Hume Coal and Berrima Rail Project

Response to the Independent Planning Commission Assessment Report dated 27 May 2019

Prepared for Hume Coal Pty Ltd
April 2020

Figure 9.1 Annual wind roses – Hume 1 meteorological station – 2013 to 2018

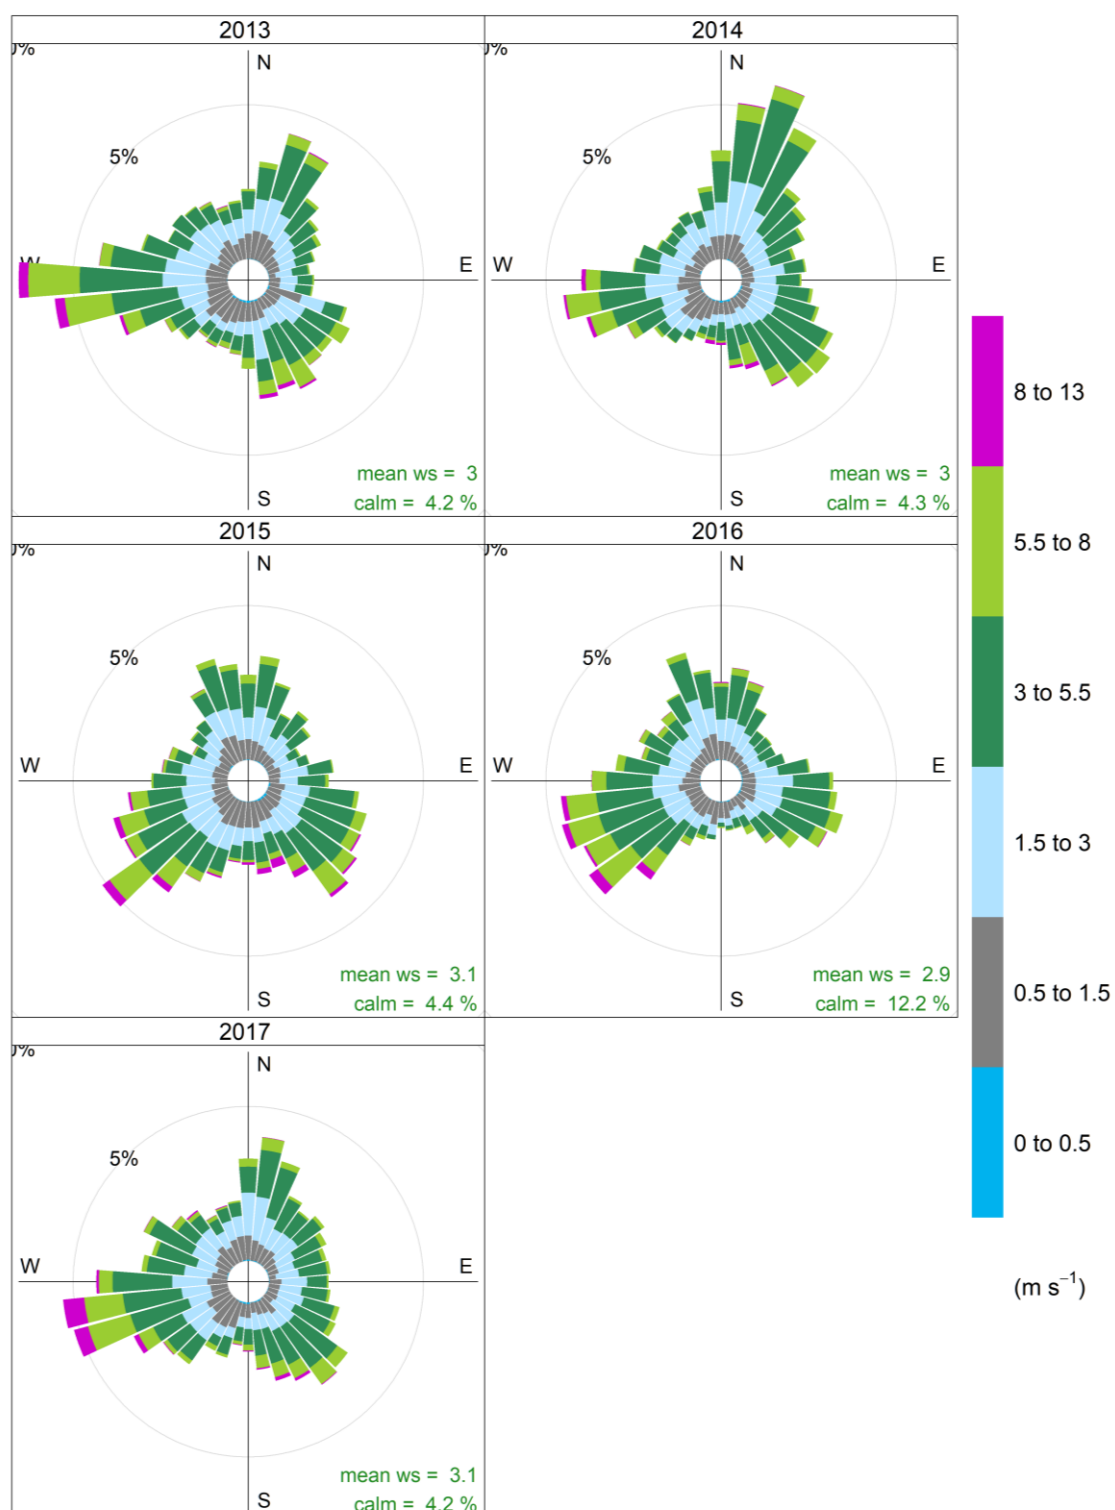
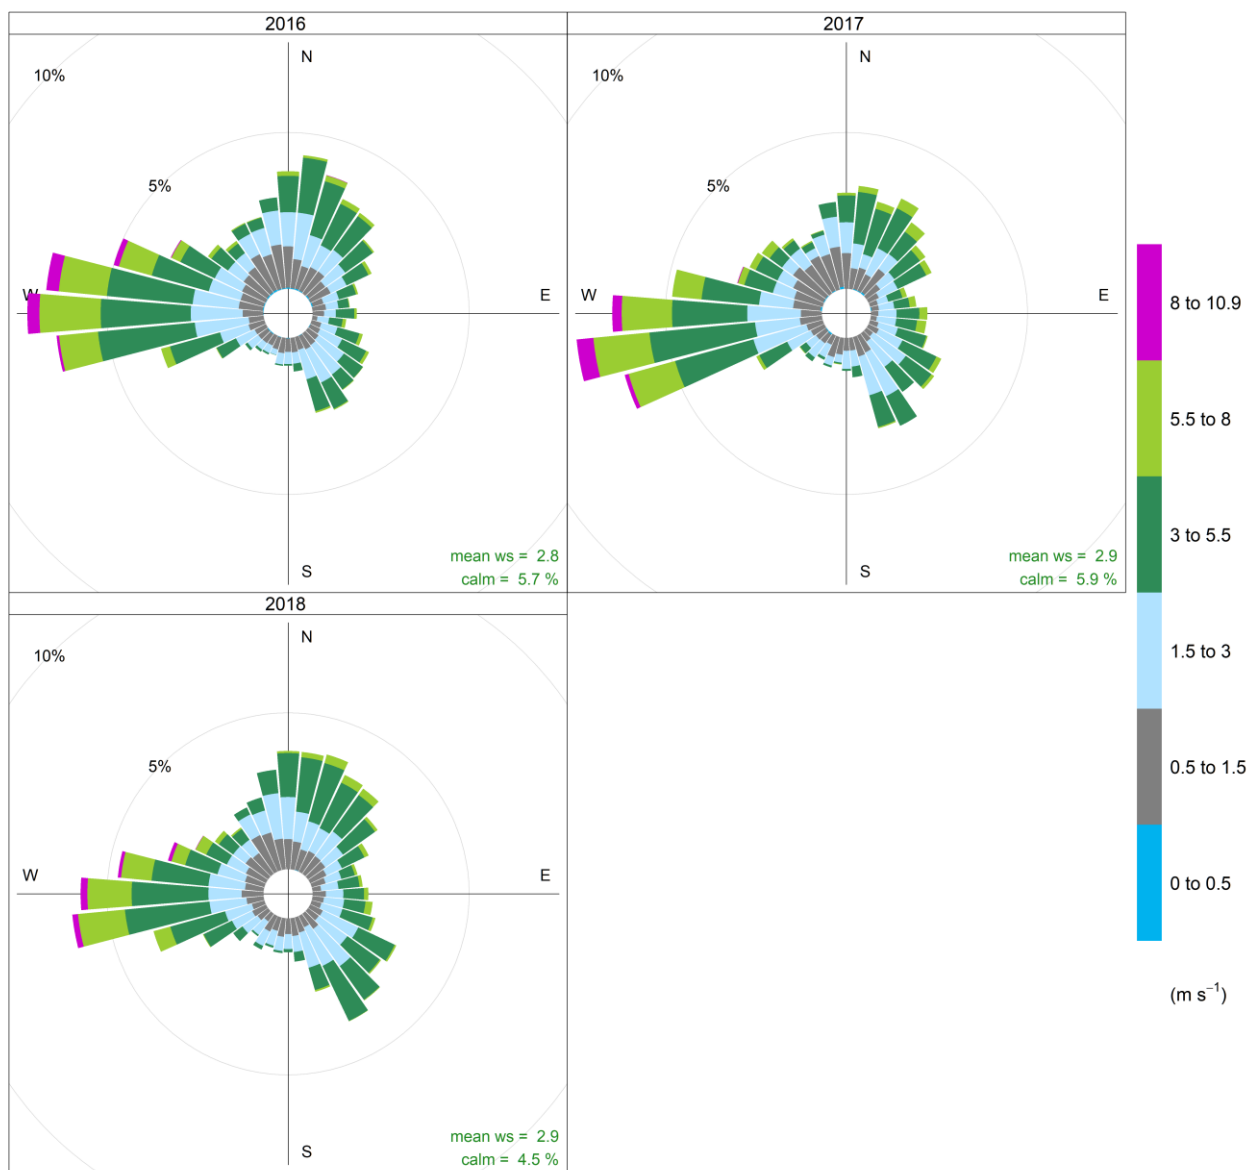
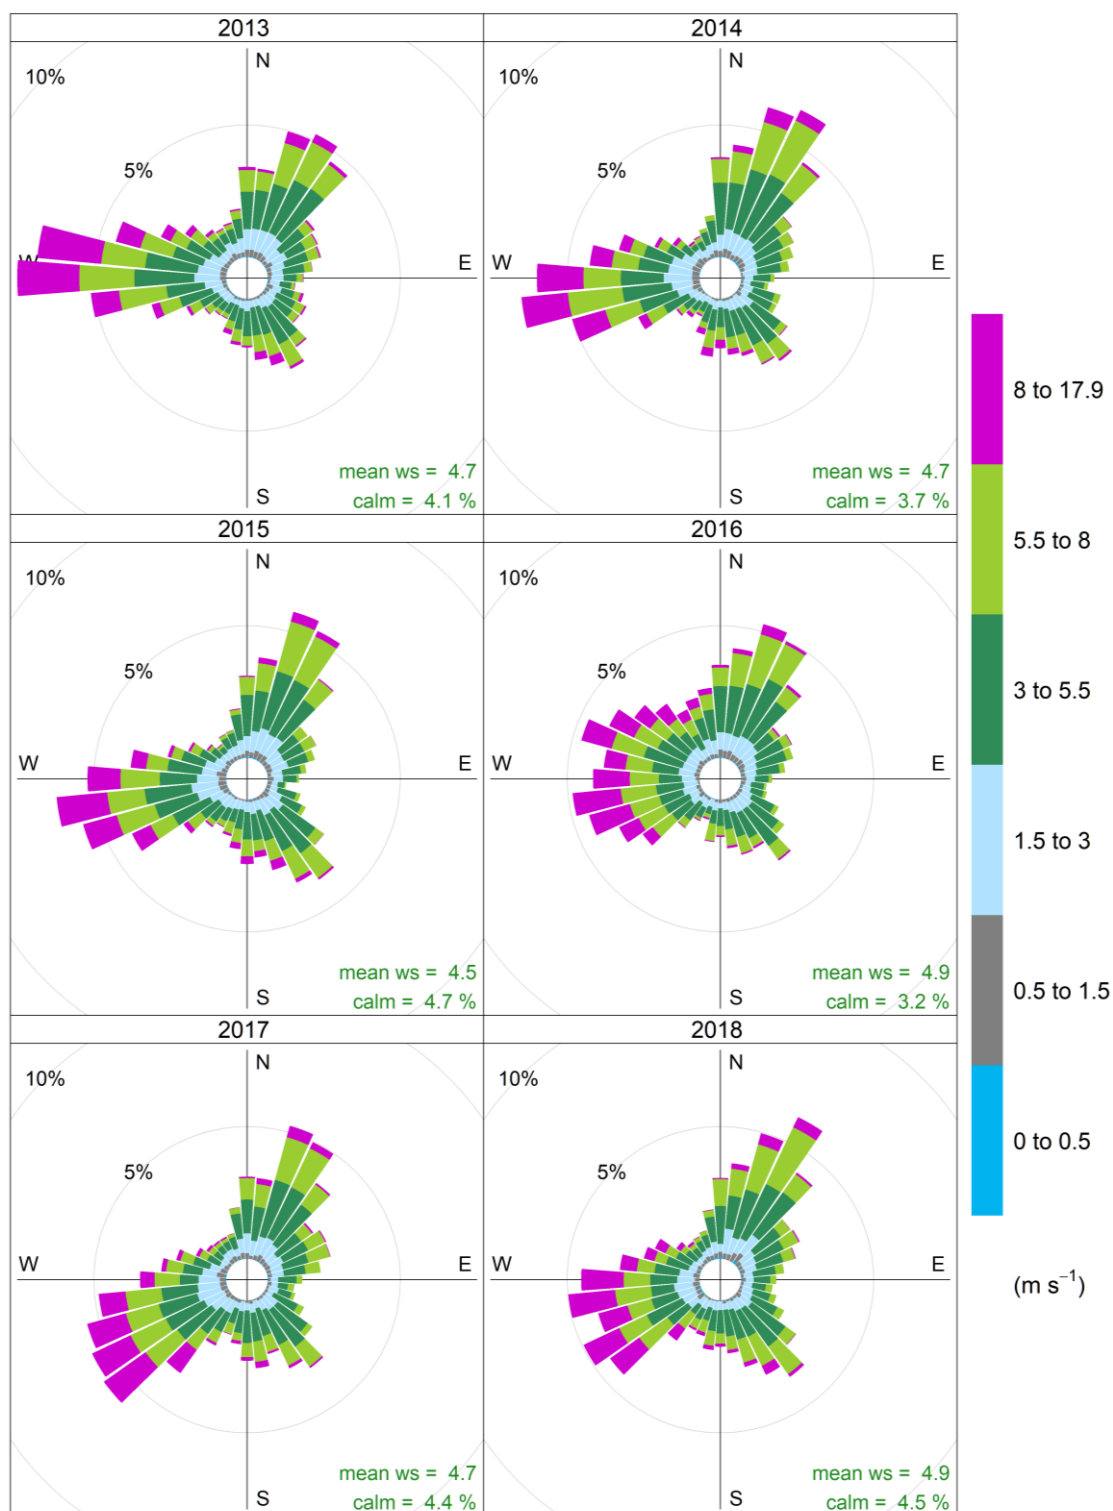
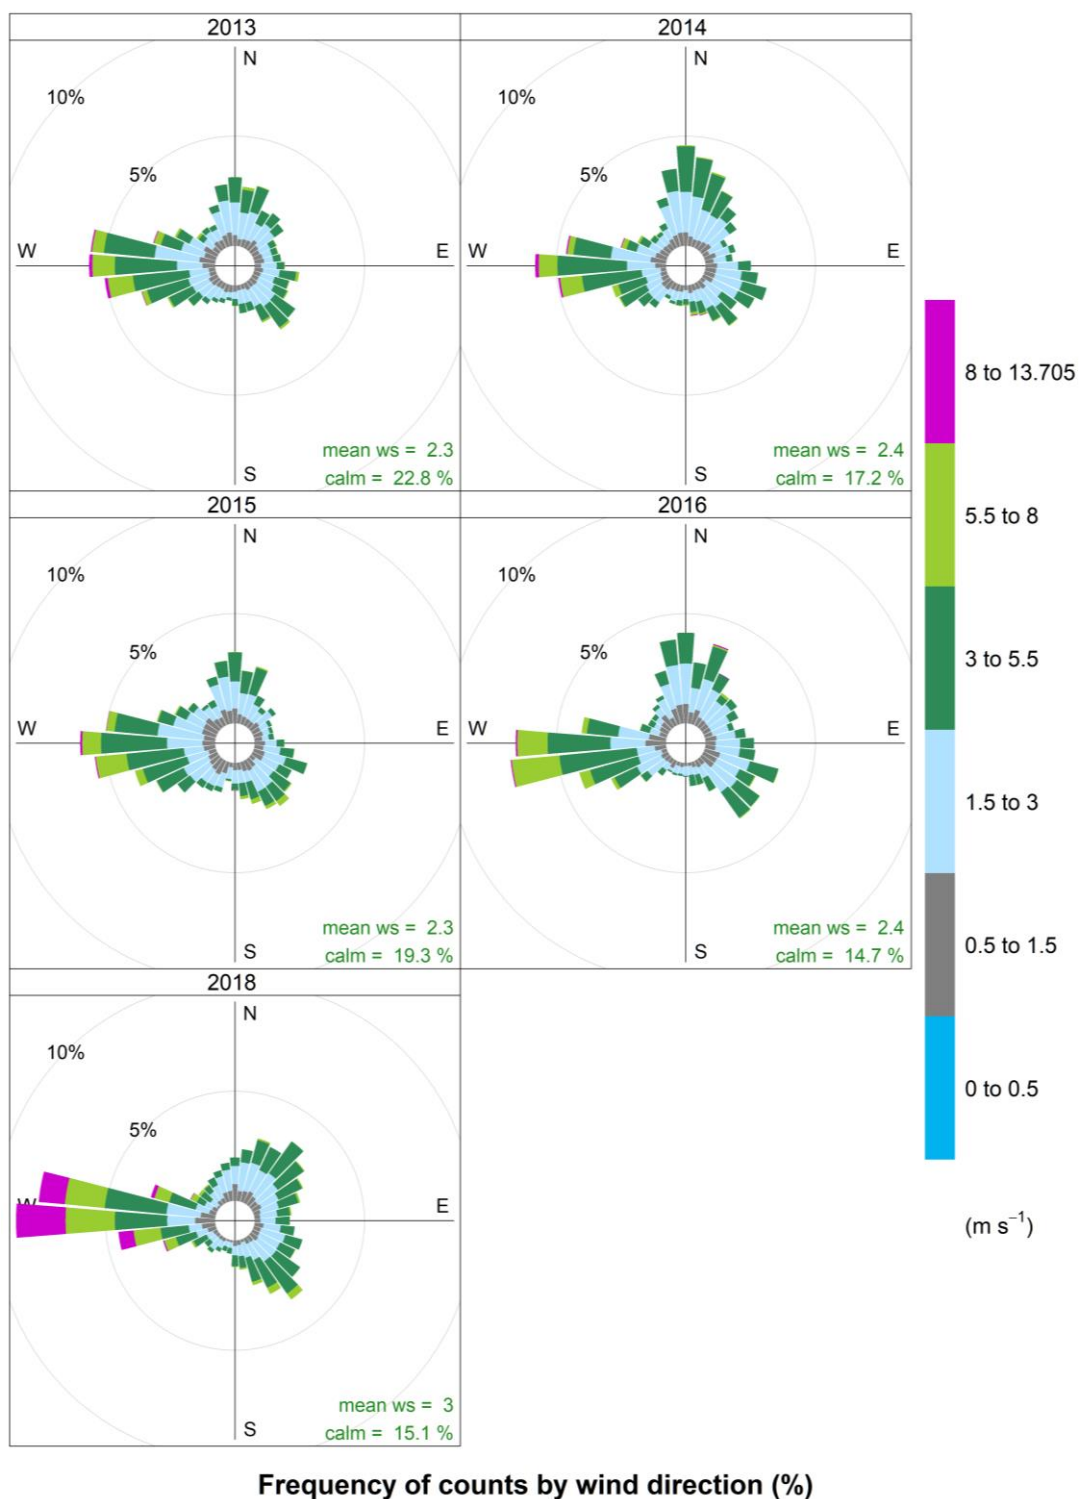
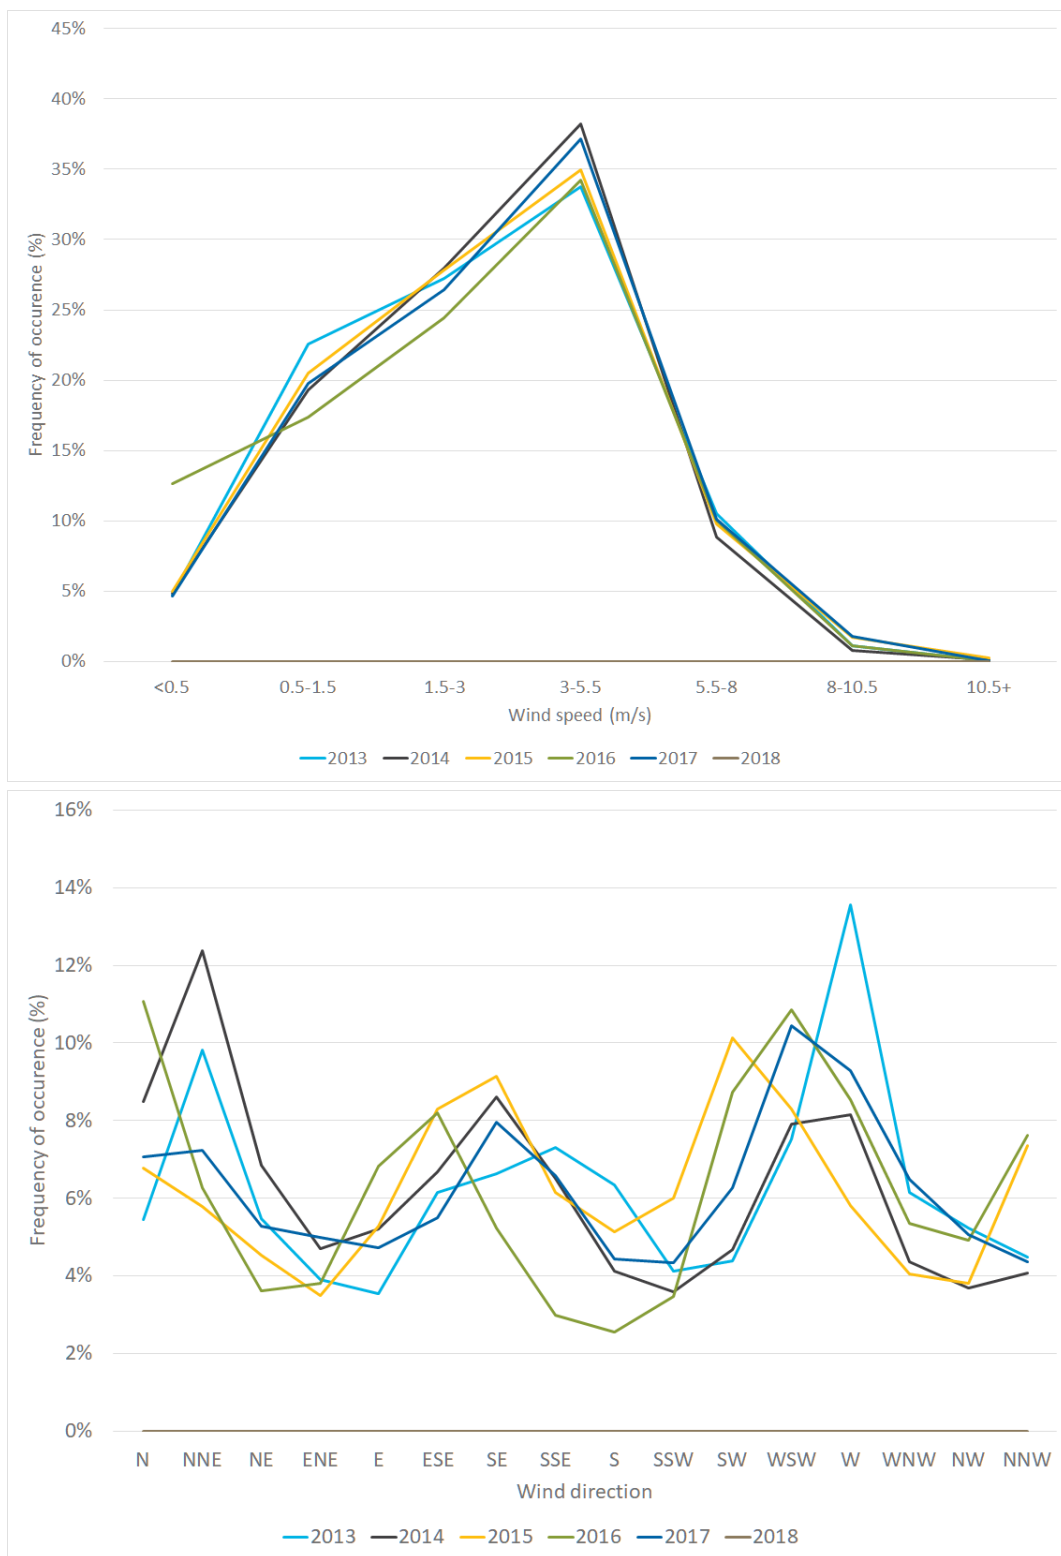
Reference number	IPC recommendations	Summary response
R12	The Department's Final Assessment Report should confirm the suitability of the assumptions in the Applicant's modelling in relation to the prevailing wind data utilised as this was questioned by members of the public in submissions.	<p>Analysis of annual wind roses for the four monitoring stations showed the consistency and similarity in recorded wind speed and direction profiles over a four-year basis. The analysed data supported the use of the 2013 meteorological monitoring datasets used for the AQIA undertaken for the EIS. The use of the different meteorological datasets addresses any potential uncertainty relating to the suitability of wind speed or directions applied in the dispersion modelling.</p> <p>It is repeated that the wind speeds recorded at the BoM Moss Vale dataset in the modelling are the highest of the four reviewed monitoring resources. The use of elevated wind speeds (average and gust conditions) from BoM Moss Vale AWS in the emission calculations returns the highest potential for dust emission generation. Consequently, the use of the BoM Moss Vale AWS provides an upper bound estimate of emissions from the Project.</p> <p>As demonstrated in the AQIA and within this chapter, the dispersion modelling is based on two meteorological datasets that are representative of the range of dispersion conditions likely to be experienced in the local area. Therefore, it is considered that the likely impacts from the Project at surrounding residences and community centres have been robustly quantified.</p> <p>It is noted that in the submission from the EPA to DPIE, dated 30 June 2017, the EPA review comments relating to the AQIA "did not identify any issues that have the potential to alter the overall conclusions and outcomes of this assessment".</p>

To further demonstrate the suitability of the monitoring data adopted in the AQIA, data recorded at all four stations has been collated and analysed between 2013 and 2018. Interannual wind roses are presented for Hume 1 (Figure 9.1), Hume 2 (Figure 9.2), BoM Moss Vale (Figure 9.3) and Boral Berrima (Figure 9.4). Further, frequency distribution plots for wind direction and wind speed are presented for each station between Figure 9.5 and Figure 9.8.

The following points are made in relation to the annual wind roses and frequency distribution plots presented between Figure 9.1 and Figure 9.8:

- across all stations, the wind roses presented illustrate similarity in the recorded wind speed and direction profiles on an inter-annual basis;
- all stations and years exhibit similar dominant wind direction profiles to the data analysed for the AQIA, namely a dominance of westerly, south-easterly and north-easterly air flow;
- the average wind speed and frequency of calm winds presented for each site and year are consistent with the 2013 dataset that was adopted for the dispersion modelling in the AQIA;
- the recorded wind speeds at the BoM Moss Vale AWS are consistently higher than the other presented monitoring stations, consistent with the analysis from the AQIA; and

- the Hume 2 wind roses recorded from 2016 onwards illustrate a similar profile to the wind roses presented for Hume 1 between 2013 and 2018, supporting the use of the Hume 1 station data in the AQIA dispersion modelling.

Despite issues with completeness of monitoring data from the accessed monitoring resources, it is considered that the data analysed above supports the use of the 2013 meteorological monitoring datasets from the BoM Moss Vale AWS and Hume 1 monitoring stations in the AQIA. It is reiterated that the dispersion modelling conducted utilised two complete 12-month meteorological datasets, which is beyond the recommendations of the Approved Methods for Modelling, therefore confirms the suitability of the assumptions used. The similarity in wind direction profiles observed across multiple monitoring data resources and years, is considered consistent and therefore the use of the two meteorological datasets addresses any potential uncertainty relating to the suitability of wind speed or directions applied in the dispersion modelling is justified.
